Product Change Notification: P-20-020072

Implement an alternative manufacturing location - 1502 plant

# Alternative Manufacturing Location PN 282080-1

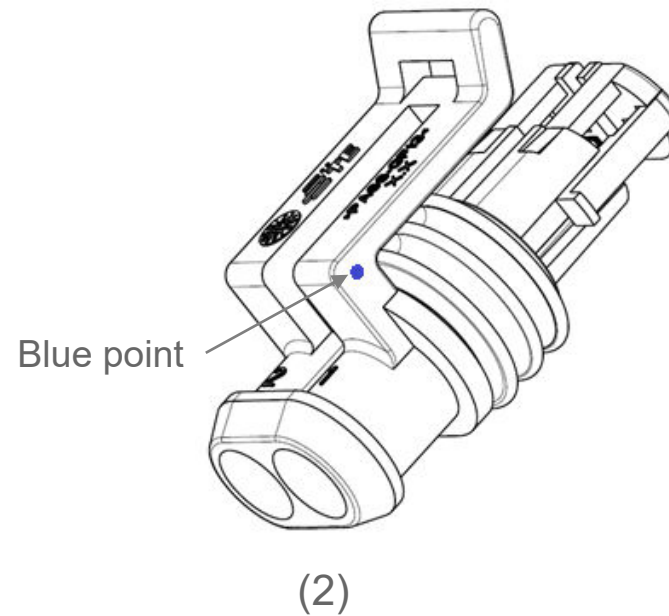
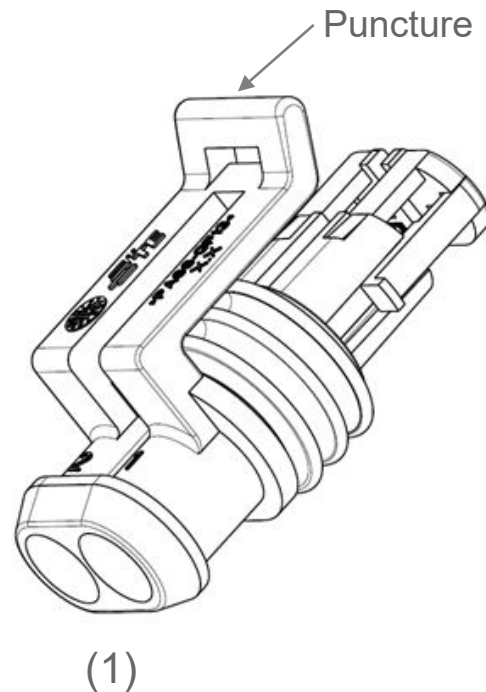
We hereby inform you that TE is performing a change in the production place.

This movement will not impact manufacturing technology nor current production process or staff. The related part/process approvals will be done in accordance with internal TE standards and upon request, customer requirements.

Actually the PN 282080-1 is assembled in an automatic machine on TE Connectivity, but with the volume's increase, an alternative available is assembly this product in a manual method on our supplier.

- Process / Product validation
  - QIP [Quality Inspection Plan] results evaluation.
  - PPAP will be updated and resubmitted.
  - (1) All parts manufactured on automatic assembly are marked with pneumatic puncture.
  - (2) All parts manufactured on manual assembly will be revised 100% and marked with a blue point.
